# IC Corporation

## AUTHORIZED FIELD CHANGE

**AFC # 03402**

**Subject File: Flip Seat Cushion Width**

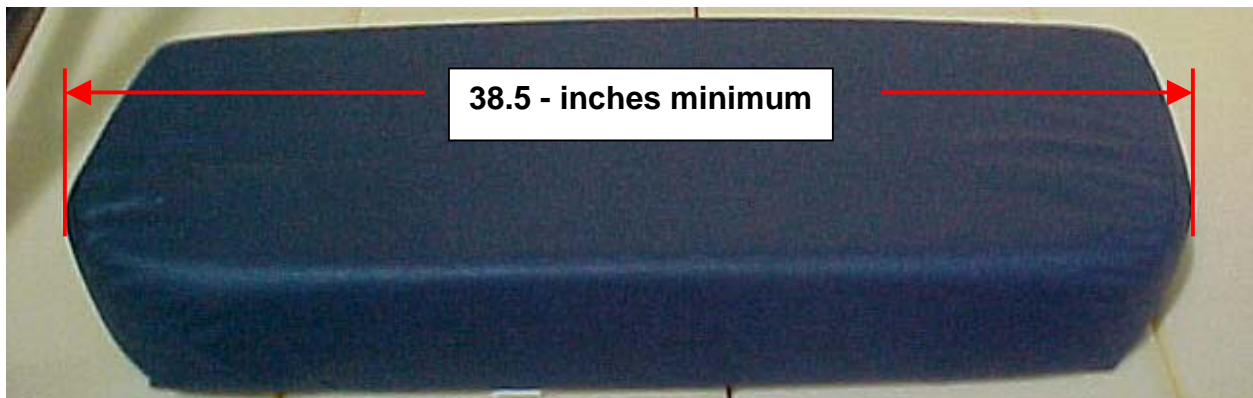
Certain buses built for the state of New York with 39-inch wide flip seats did not meet the state's requirement for the seat cushion to be 39-inches wide. The New York Department of Transportation ("NYDOT") has advised that, if this seat cushion does not meet a minimum of 38.5-inch width at the next NYDOT inspection, the bus will be removed from service until the seat cushion width is fixed or the capacity label of the bus is reduced by one.

Inspect this unit by measuring the width of the flip seat cushion. See picture below for proper method of measurement. If the width does not meet the accepted 38.5-inch width requirement, please refer to the following repair procedure.

The repair procedure involves removing the defective seat cushion from the seat frame by removing the six (6) screws that retain the clamps used to secure the cushion to the seat frame. Before removing the brackets mark the location on the seat frame to assist in installing the new cushion. To install the new cushion assembly make sure that the back of the cushion fits against the hinges and use the same fasteners and brackets, located in the original position, to secure the cushion to the seat frame. After installing the cushion, make sure that the seat will automatically return to the folded position to provide the required aisle to the exit door.
